Ward: College Park And Old Oak

2022/01249/OPDOBS

Consultation by OPDC on 22/0064/HS2OPDC Application under Schedule 17 of the High Speed Rail (London-West Midlands) Act 2017 for works associated with the urban realm for the new Old Oak Common station comprising earthworks; wetland area earthworks; retaining walls; bus canopies; fences and walls; bollards; seating; planters; cycle stands; lighting equipment; a DNO substation; hard and soft landscaping; road vehicle parks and onsite road layout.

OFFICER'S REPORT

Figure 1 – Proposed urban realm scheme overview

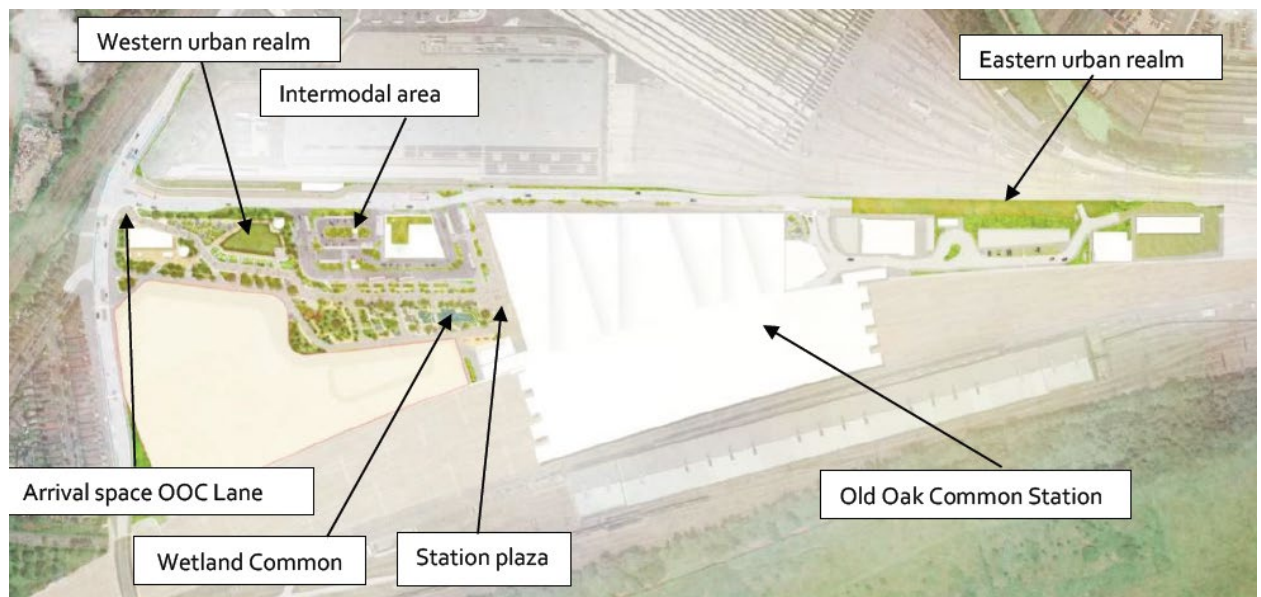
- 6.1.1. The design principles of the urban realm strategy are generally considered to represent a high quality of design. The scale, variety and detailing of public spaces and landscape features will provide a positive environment for local residents, visitors and those interchanging at the station to enjoy throughout the day. These features would also support the future development ambitions of key sites within the local area.

- 6.1.2. Whilst the general principles of key areas of the urban realm towards the west of the main station entrance are strongly supported, the experience of spaces to the northern/eastern aspect of the station environment would benefit from additional design development to ensure that these spaces maximise opportunities for passive surveillance and activity in order to become safe and attractive spaces overall. Delivery of the second (eastern) station access would also be encouraged in this regard.

- 6.1.3. The design of the urban realm strategy serves to create strong and meaningful pedestrian and cycle route connections between the station and Old Oak Common Lane. However, as has been discussed throughout pre-application discussions, it is disappointing that more strategic opportunities to integrate additional connectivity to Scrubs Lane, the Grand Union Canal and Wormwood Scrubs are not to be delivered by the urban realm from day one of the railway operations.
